Service Bulletin

E126

PACCAR MX-13 EPA2013 MY2015 Replacement of Expiring Emissions Labels

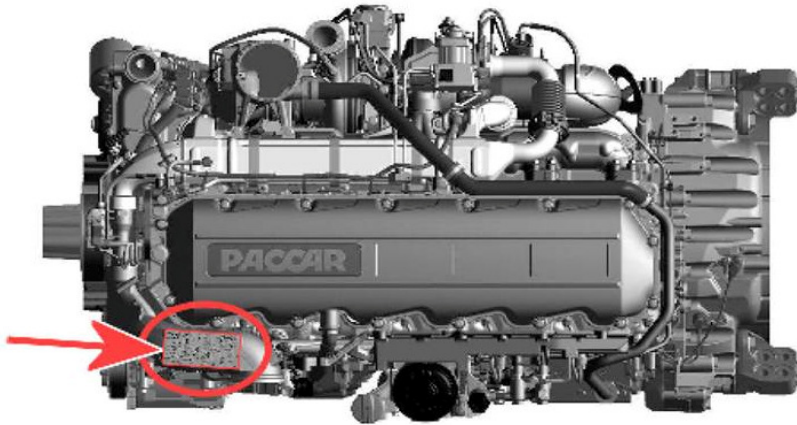
- 1) Remove the Test Exemption EPA/CARB label from the engine's valve cover or intake pipe. This label **MUST** be removed before installing the replacement label.

- 2) The EPA/CARB label must be placed on the intake pipe as shown below.
